# ARMORED MEDICAL RESEARCH LABORATORY

Final Report On

PROJECT NO. 44 - PHYSIOLOGICAL AND OPERATIONAL CHARACTERISTICS  
OF M-24 TANK

8 November 1944

# OVERALL LIMITS OF GROUND VISION ( ALL CREW MEMBERS ) M 24 TANK

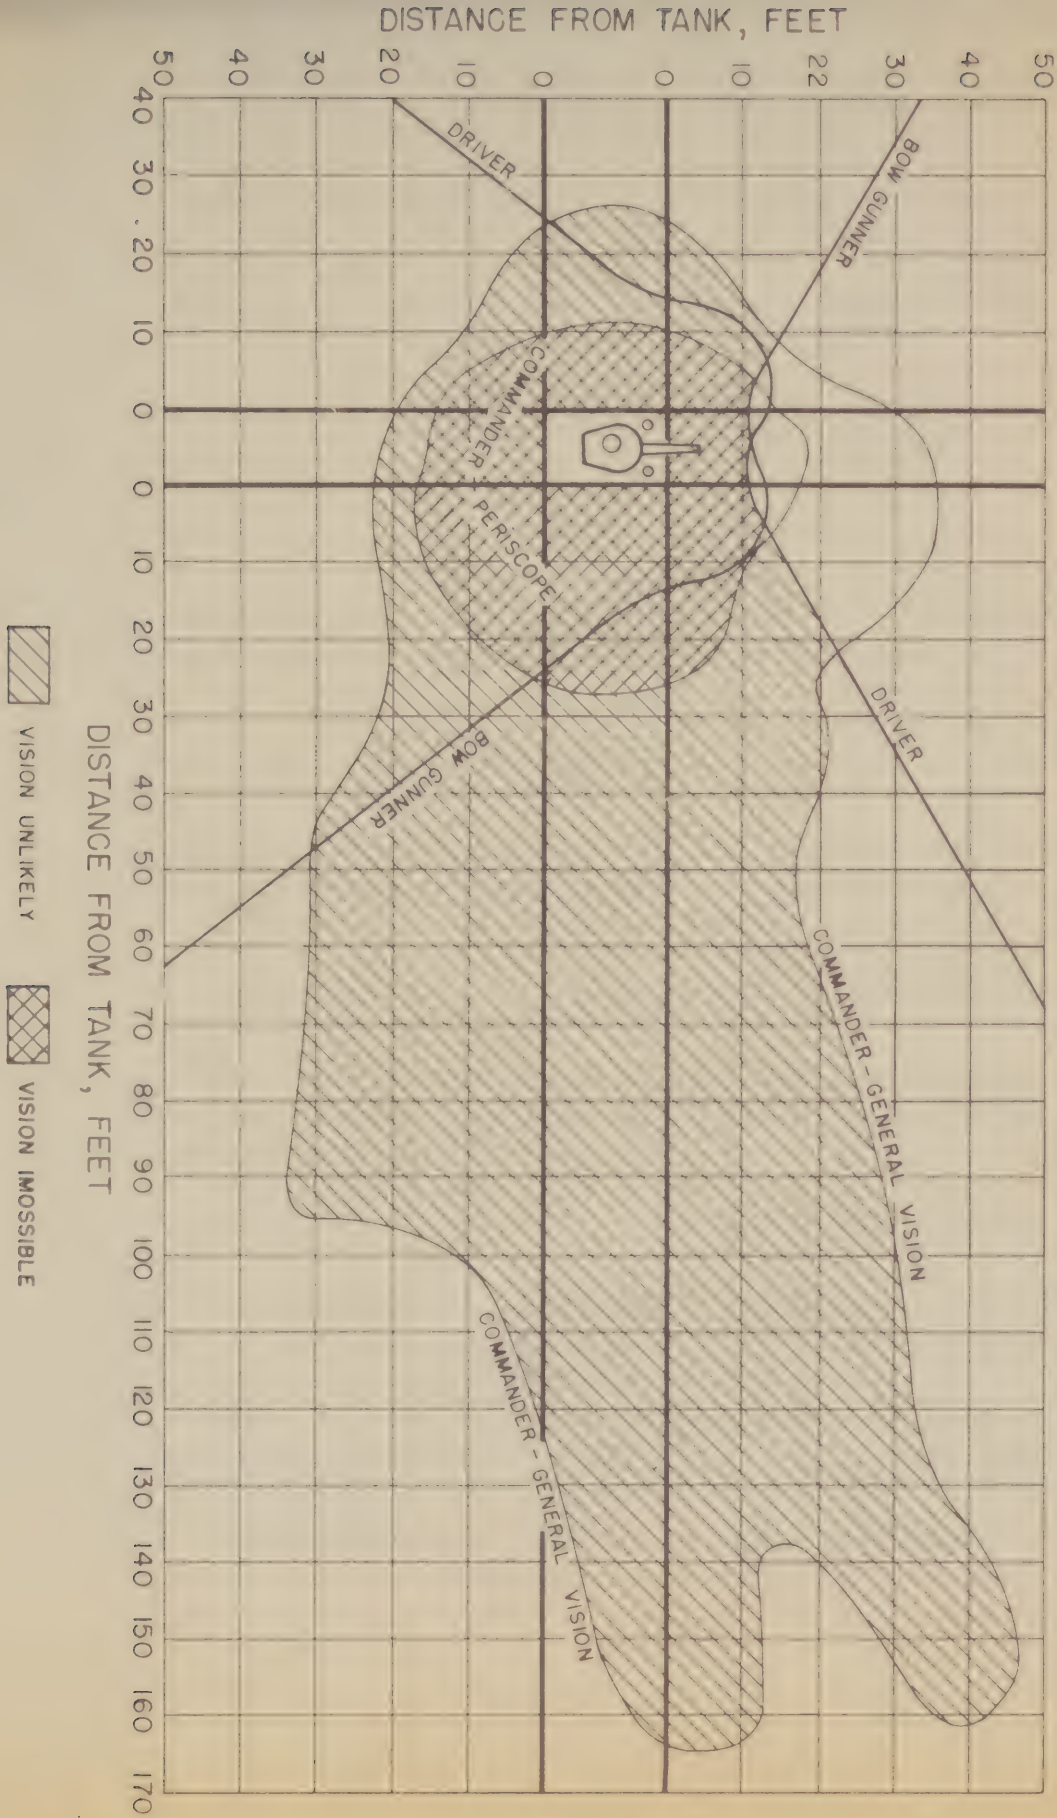
c. Provisions for close-in general vision are inadequate.

c. Immediate consideration be given to the development of an improved vision cupola with less limited ground vision and installation of vision units to provide close ground vision on the loader's side.

The overall limits of close-in ground vision from all the various crew positions are shown in Figure 1 and for the driver in more detail in Figure 2. The absence of close-in vision on the right flank and poor vision on the left are serious faults, especially in view of the probable use of this tank in Pacific theatres where protection against ground troops is particularly required. In order to increase the close-in vision, an improved vision cupola for the commander is needed and rhombic vision units to provide vision within 5 feet of the tank should be installed in the right turret wall for use by the loader.

The provision of an improved vision cupola in future production is considered desirable. No vision device which will result in decreasing the armor protection now afforded is considered acceptable.

LIMITS OF DRIVER'S GROUND VISION

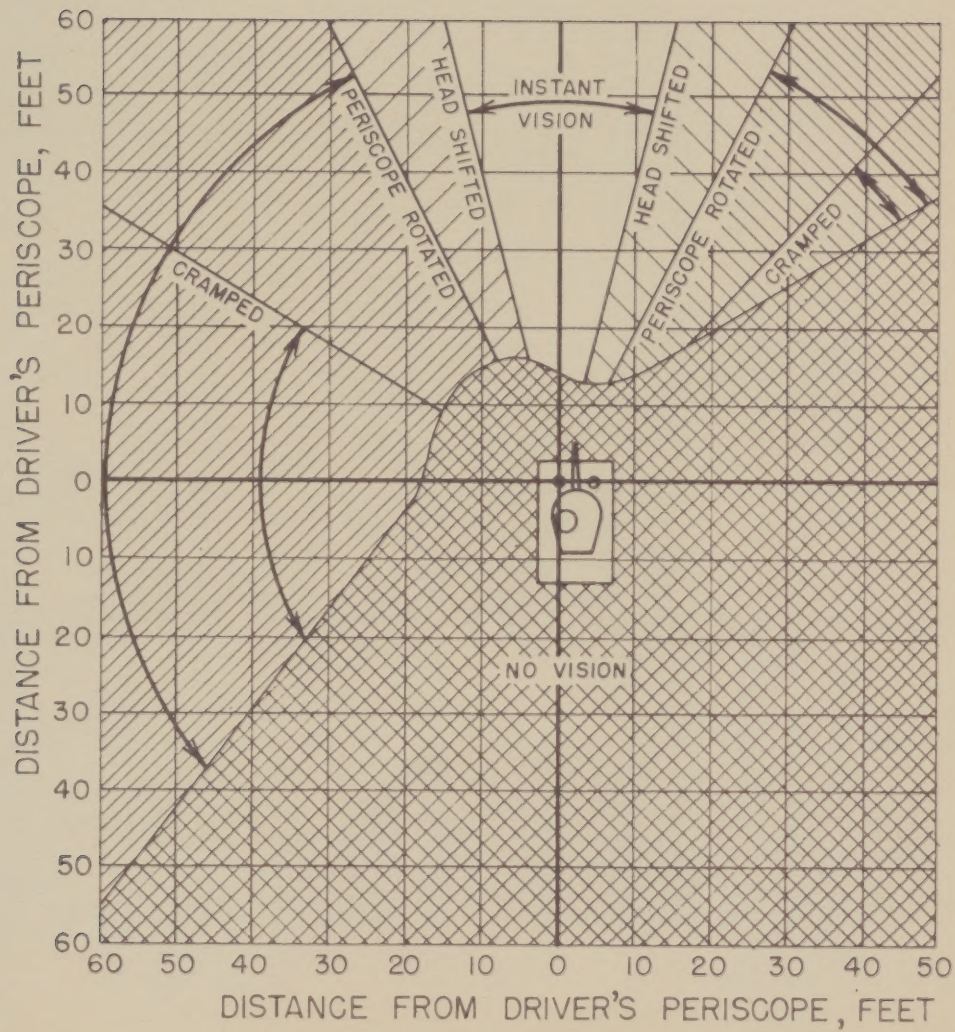
d. Driver's vision should be improved.

d. Immediate consideration be given to improvement of driver's vision.

Driver's vision is limited by the restricted field of view of the present periscope. Wide-field vision units should be provided; for suggested approach to design see AMRL report on Analysis of Physiological Characteristics of T9E1 Tank, dated 27 March 1944 and report on Driver's Vision in Landing Vehicle Tractor, dated 9 March 1944.

Improvement of driver's vision is desirable, but must be accomplished without decreasing the armor protection now afforded.

RECOMMENDED POSITIONING OF TURRET  
 LIGHT FIXTURES IN M-24 TANK

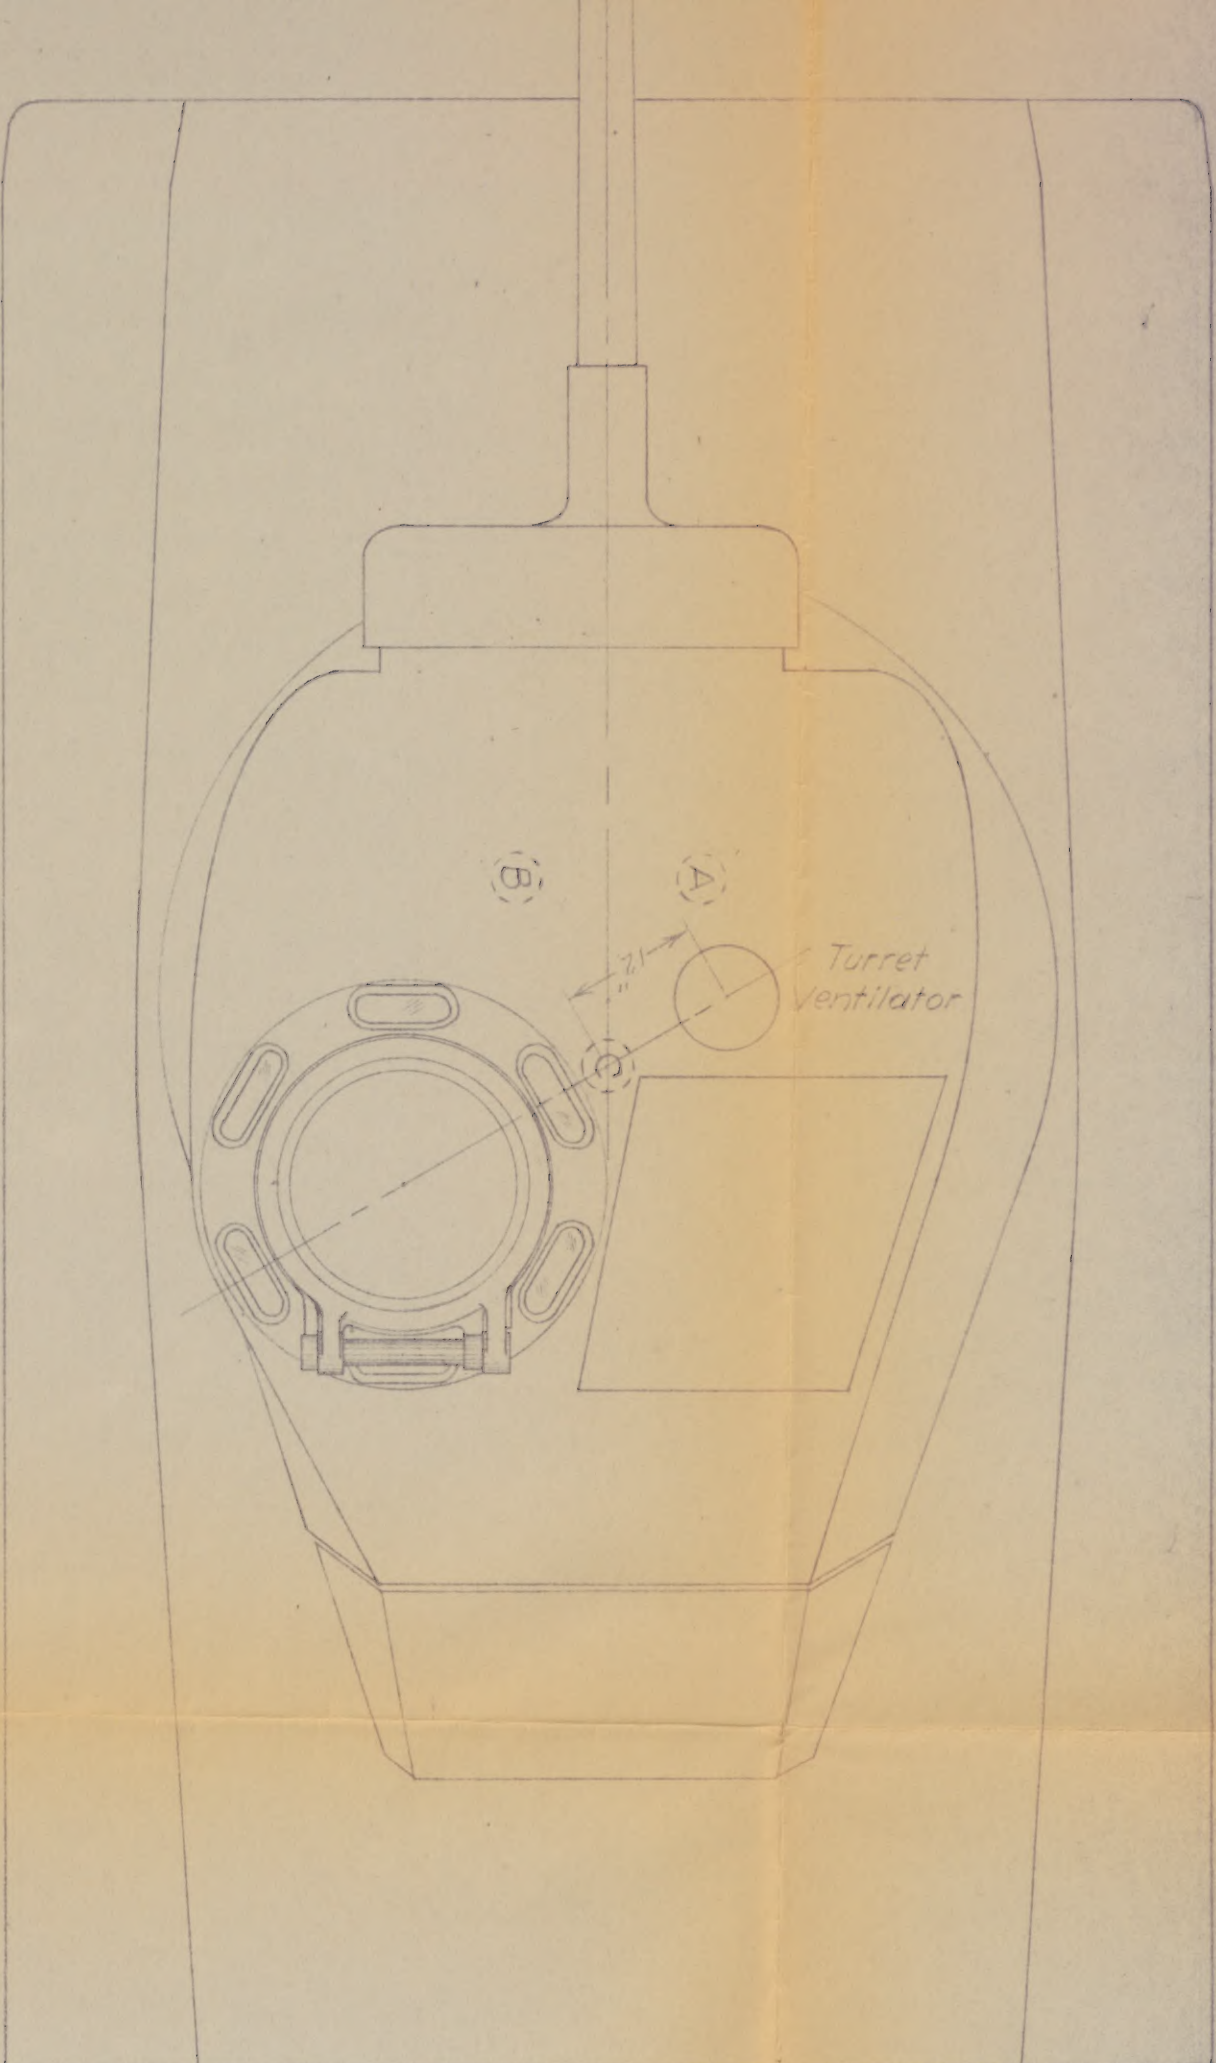
m. Re-locate forward turret light fixture to central position shown in Figure 3.

The present positioning of light fixtures in the turret does not allow sufficient light for the commander for map reading. The left forward turret fixture should be moved from existing position to central location shown in Figure 3. This position also provides more general illumination on main gun breech and radio.

*Fixture A to remain in existing position  
 Fixture B to be moved to position C*

m. Paragraph 4m. Desirable for future development.
